Access Compliance Report Public Rights-of-Way (RR Crossings)

Intersection ID: 10025367	Main Street: E_8TH_ST	Location: N/A
ADA ID: B3117B8A34BA	Overall Compliance: No	Severity Score: 0.0
Codes/Mitigation Info/Possible Solution		Field Measurements/Component Compliance

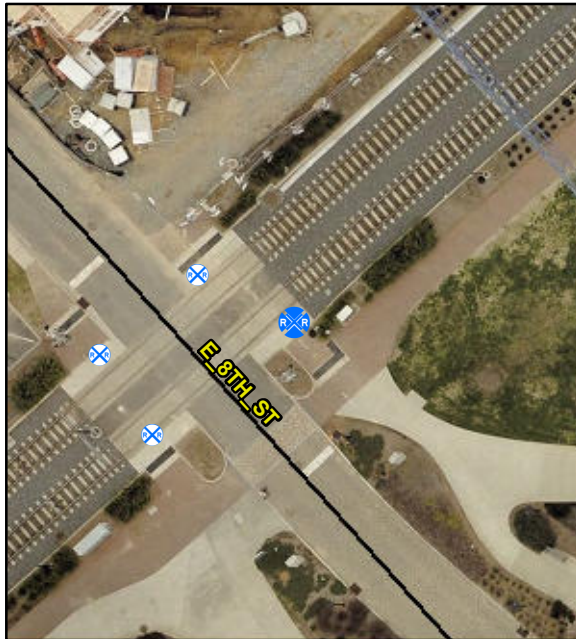
Compliance	Description	Data
Yes	DWS Provided?	Yes
Yes	DWS Contrast?	Yes
Yes	DWS Width (in)	Yes
Yes	DWS Length (in)	24.0
No	DWS Offset (in)	197.0
No	Pedestrian Gate?	No
N/A	DWS Outside Gate?	No
N/A	Rail Type?	LightRail
No	Flangeway Gap (in)	2.5
Yes	Sidewalk Width (in)	96.0

Remove & Replace Detectable Warning System. Provide Pedestrian Gate. Remove & Replace Walking Surface Adjacent to Rail.
